Access Compliance Report

Public Rights-of-Way

(Curb Ramps)

Intersection ID: 16702	Main Street: SELWYN_AV	Cross Street: WELLESLEY_AV	Location: S
ADA ID: 668FC8EFDEB9	Ramp Type: PerpDiag	Initial Pass/Fail: Fail	Overall Compliance: No
Severity Score: 12.5			
Codes/Mitigation Info/Possible Solution		Field Measurements/Component Compliance

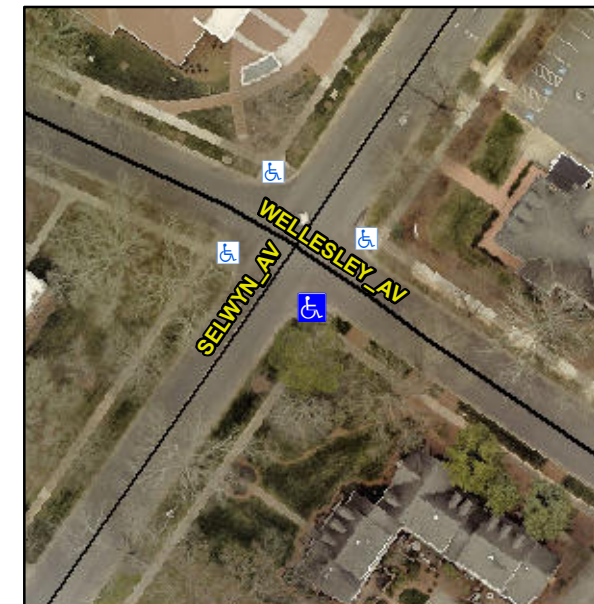
Not Found, R304.5.3

Compliance	Description	Data	Compliance	Description	Data
N/A	Ramp Length (in)	96.0	Yes	Ramp Slope (%)	6.4
Yes	Ramp Width (in)	87.0	No	Ramp XSlope (%)	6.8
N/A	Flare Type LT	N/A	N/A	Flare Type RT	N/A
N/A	Flare Slope LT (%)	N/A	N/A	Flare Slope RT (%)	N/A
N/A	Flare Traversable LT?	N/A	N/A	Flare Traversable RT?	N/A
N/A	Landing Length (in)	N/A	N/A	DWS Provided?	N/A
N/A	Landing Width (in)	N/A	N/A	DWS Contrast?	N/A
N/A	Landing Slope (%)	N/A	N/A	DWS Length (in)	N/A
N/A	Landing X Slope (%)	N/A	N/A	DWS Full Width?	N/A
N/A	Landing Curb? (Y/N)	N/A	N/A	DWS Offset (in)	N/A
N/A	Shared Landing?	N/A			
N/A	Gutter Ponding?	N/A	N/A	Gutter Slope (%)	N/A
N/A	Gutter Lip Ht (in)	N/A	N/A	Gutter X Slope (%)	N/A
N/A	Painted X Walk1?	No	N/A	Painted X Walk2?	No
	X Walk 1 Direction	To NE		X Walk 2 Direction	To NW
N/A	X Walk 1 Width (in)	N/A	N/A	X Walk 2 Width (in)	N/A
	X Walk 1 Slope (%)	2.6		X Walk 2 Slope (%)	0.7
	X Walk 1 X Slope (%)	1.4		X Walk 2 X Slope (%)	3.4

Remove & Replace Curb Ramp With Two New Directional Ramps or Equivalent.
